Planning Application under Section 16 of the Town Planning Ordinance for Proposed Residential Institution (Student Hostel) at Middleton Towers, 140 Pokfulam Road (RBL No. 825 RP) (Application No. A/H10/98)
Submission of Responses to Comments (3rd Batch)

Responses to Departmental Comments (3rd Batch)

Response to Departmental Comments – Application No. A/H10/98

Figure: 2.1	RAMBOLL	
	Title:	Existing Sewerage System in the Vicinity of the Subject Site
	Project:	Proposed Residential Institution (Student Hostel) at Middleton Towers, 140 Pok Fu Lam Road
	Drawn by:	SC
	Checked by:	TC
	Rev.:	1.2
	Date:	Jul 2026

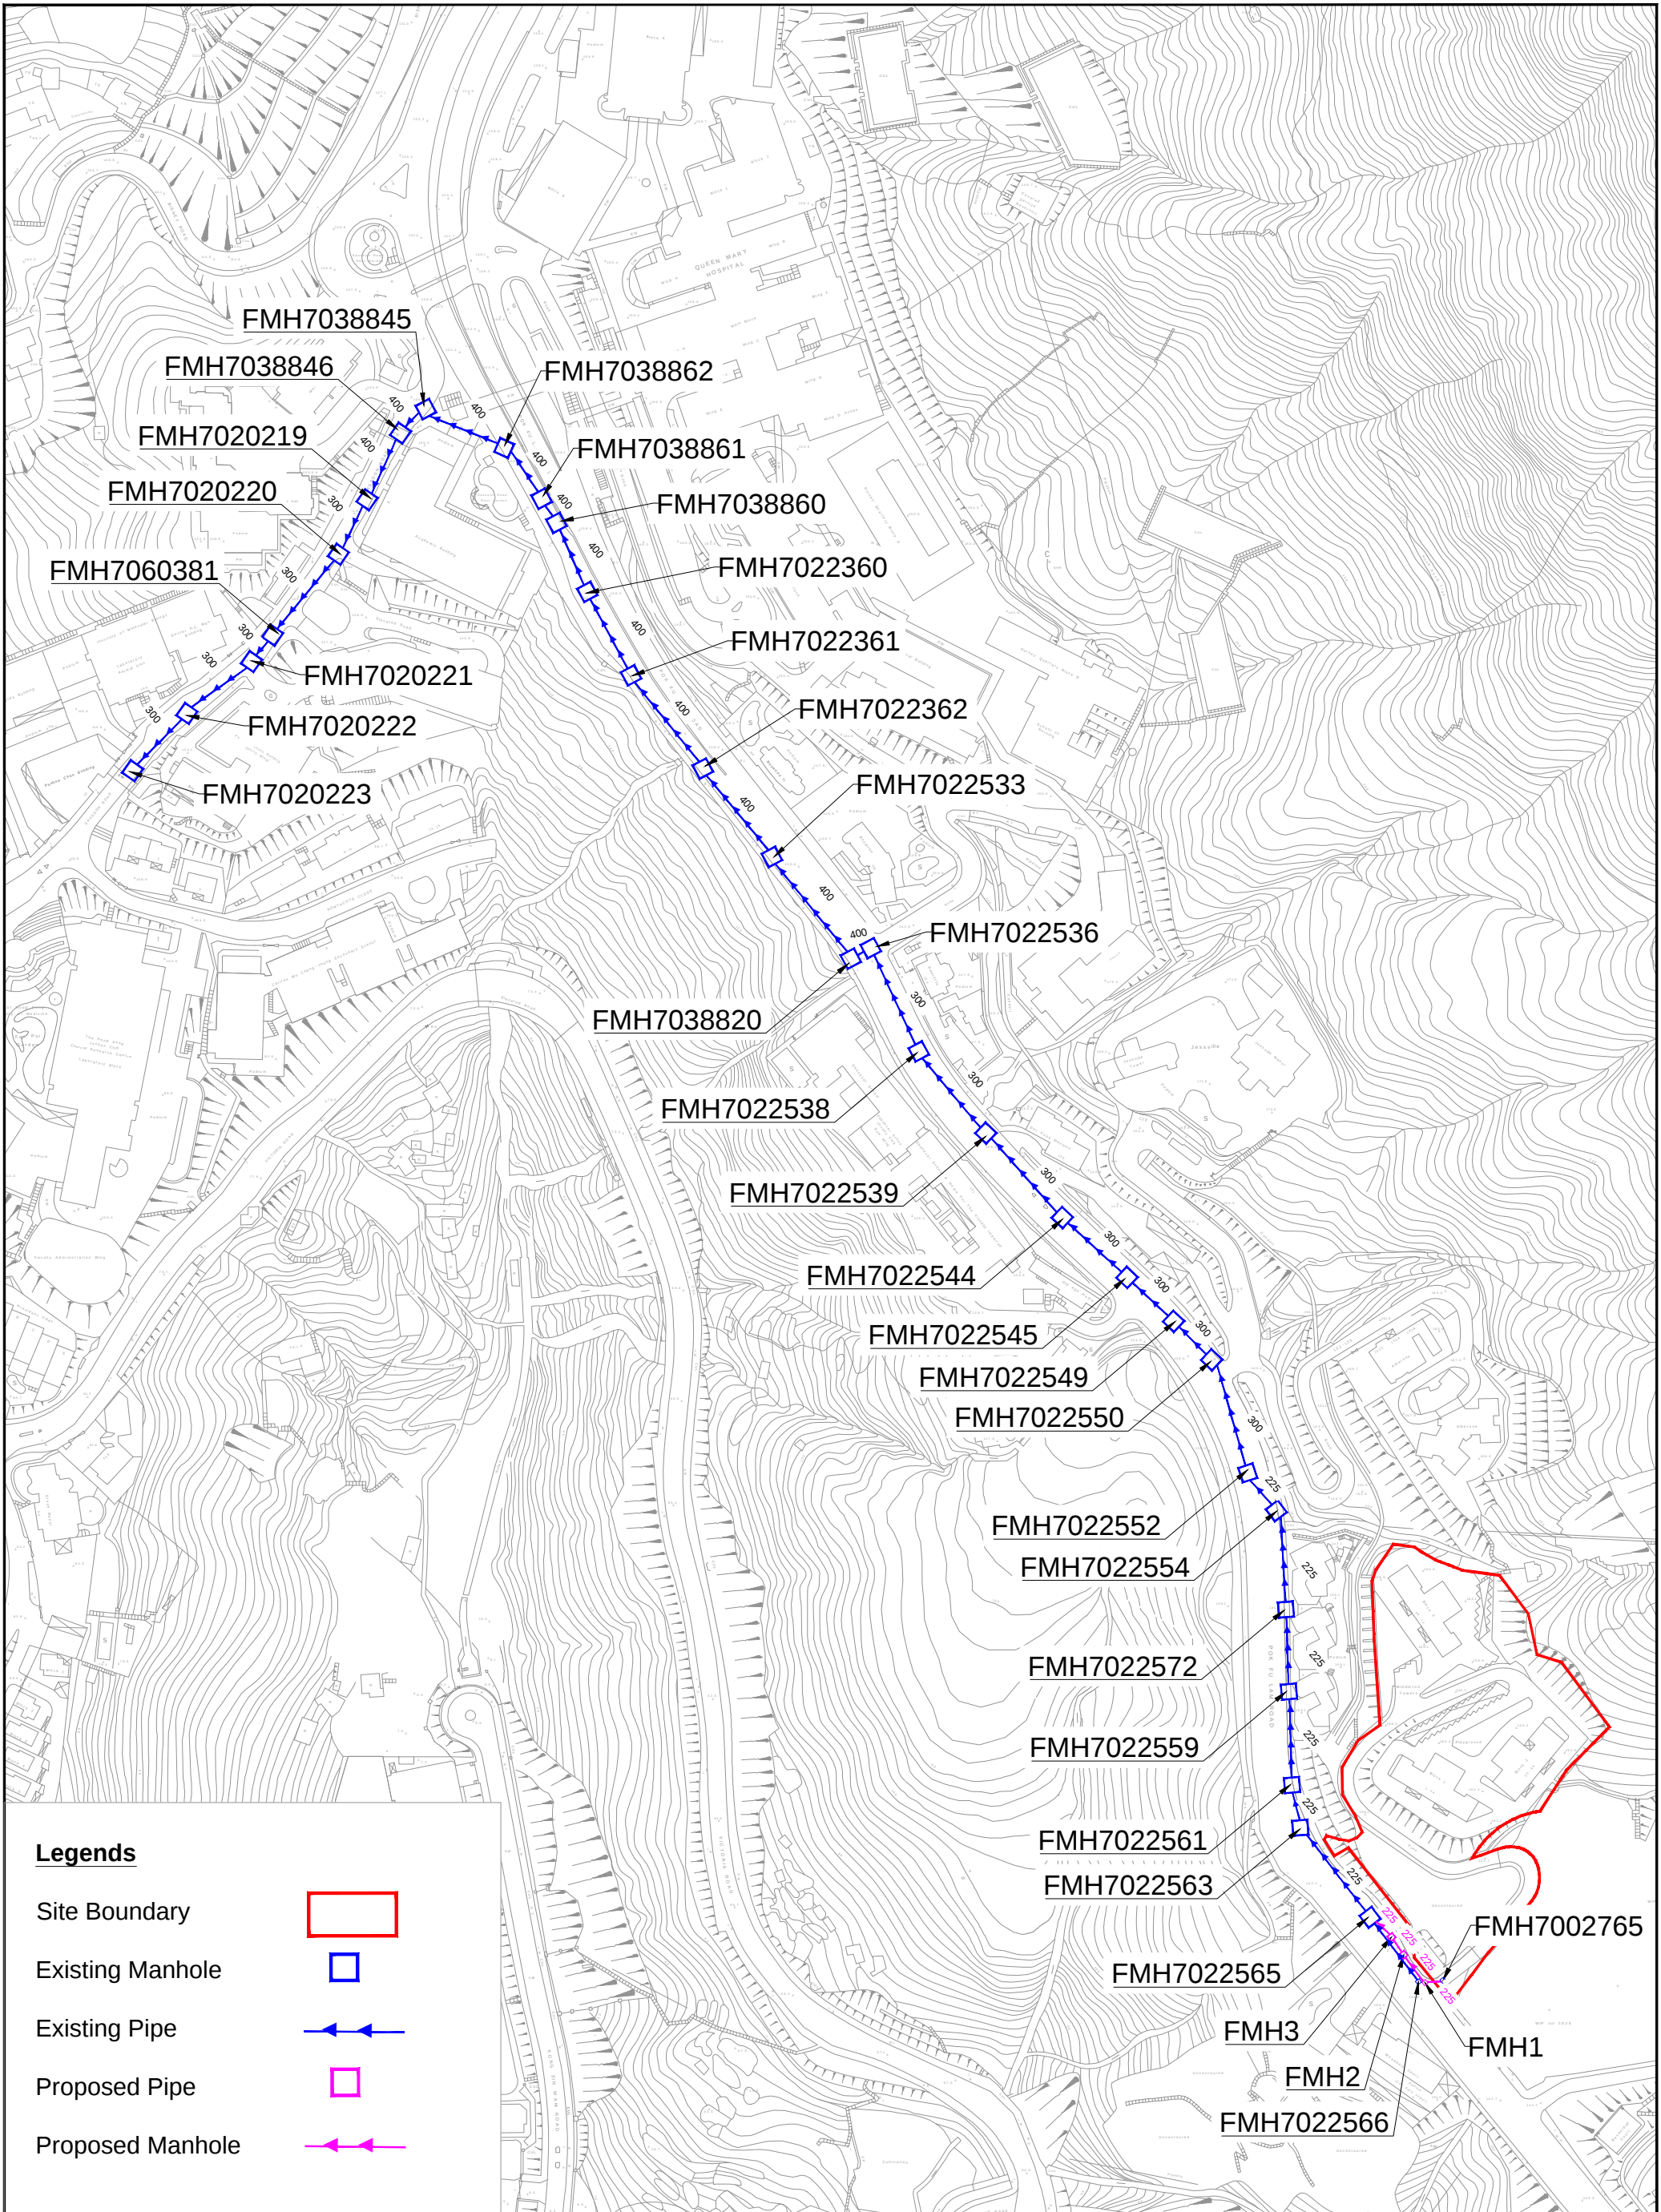
1.2.	For Section 2.5.1, it is reflected in Figures 2.1 and 2.2 that the 3 proposed terminal manholes FMH1, FMH2 and FMH3 are located at the upstream of FMH7022565 outside the site boundary, please advise if the 3 proposed manholes will be constructed between existing FMH7022566 and FMH7022565.	Please be advised that FMH1, FMH2 and FMH3 were already constructed on site as per the approved SIA for "Student Residences and Residential Development for the University of Hong Kong at 142 Pok Fu Lam Road". Please find the attachment Annex I for your reference.

Figure: 2.2

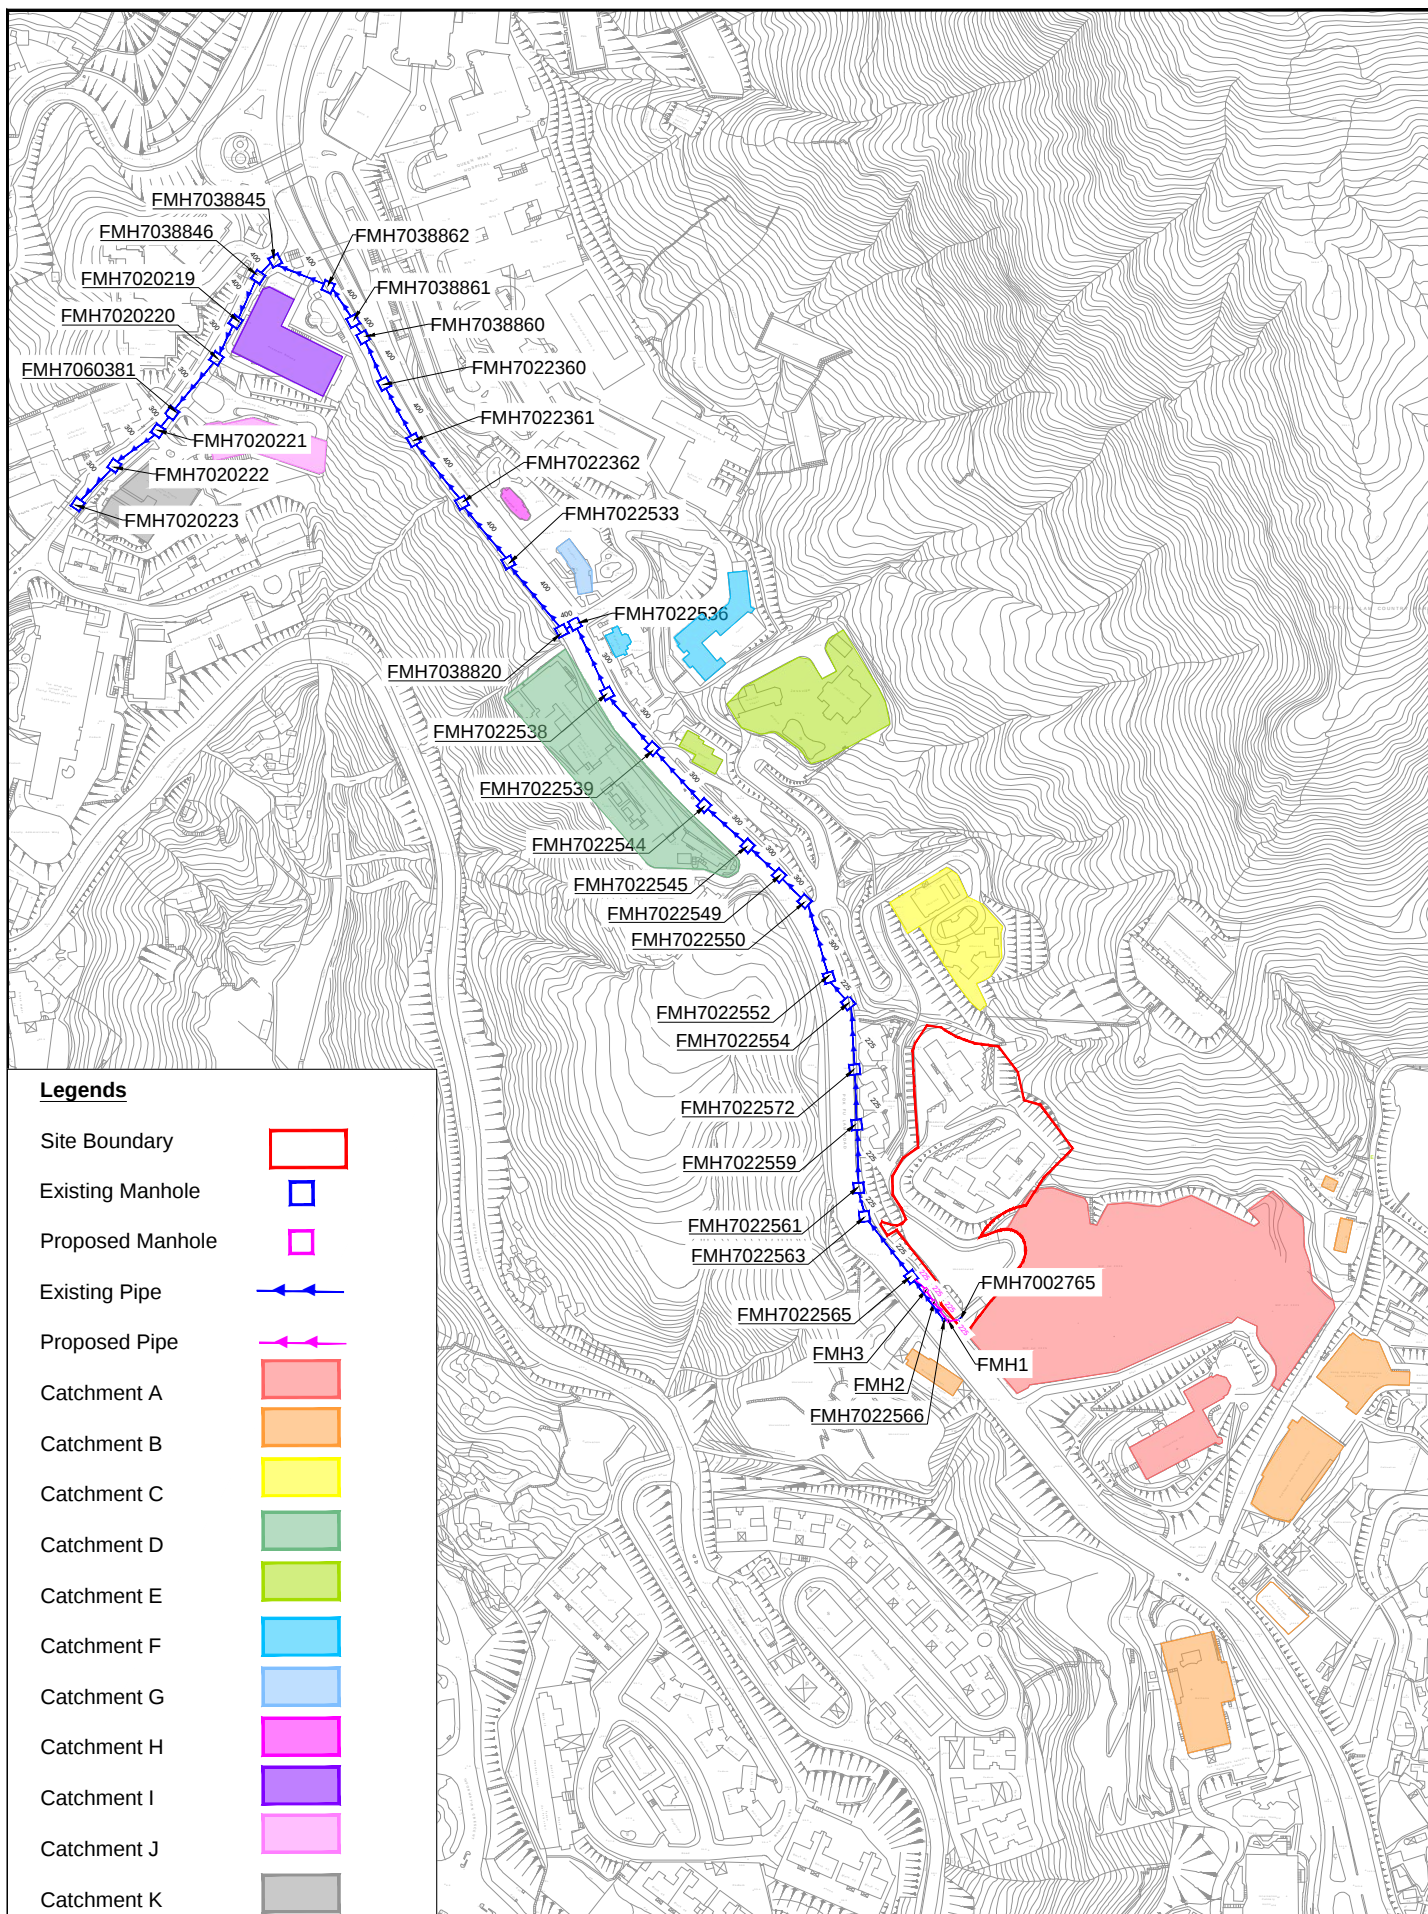
2.5.	Figure 2.2 – For the proposed new alignment/manhole, please use another colour for indication on the layout and update the legend accordingly. They should not be labelled as "existing manhole/pipe" in the legend.	Noted and updated accordingly.
